State of New Mexico  
 Energy, Minerals and Natural Resources

WELL API NO. 30-015-21953
5. Indicate Type of Lease STATE <input type="checkbox"/> FEE <input checked="" type="checkbox"/>
6. State Oil & Gas Lease No.
7. Lease Name or Unit Agreement Name Tom Brown GO Com
8. Well Number 1
9. OGRID Number 7377
10. Pool name or Wildcat Kennedy Farms; Morrow

SUNDRY NOTICES AND REPORTS ON WELLS (DO NOT USE THIS FORM FOR PROPOSALS TO DRILL OR TO DEEPEN OR PLUG BACK TO A DIFFERENT RESERVOIR. USE "APPLICATION FOR PERMIT" (FORM C-101) FOR SUCH PROPOSALS.)	
1. Type of Well: Oil Well <input type="checkbox"/> Gas Well <input checked="" type="checkbox"/> Other	
2. Name of Operator EOG Resources, Inc.	
3. Address of Operator 104 South Fourth Street, Artesia, NM 88210	
4. Well Location Unit Letter <u>C</u> : <u>835</u> feet from the <u>North</u> line and <u>1980</u> feet from the <u>West</u> line Section <u>22</u> Township <u>17S</u> Range <u>26E</u> NMPM Eddy County	
11. Elevation (Show whether DR, RKB, RT, GR, etc.) 3339'GR

EOG Resources, Inc. plans to plug and abandon this well as follows:

## Tom Brown GO Com 1 Proposed

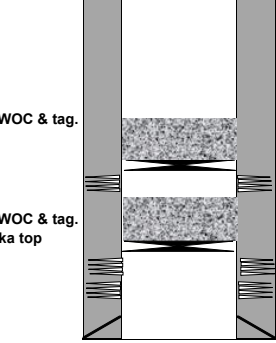
AMENDED

Run CBL to surface.
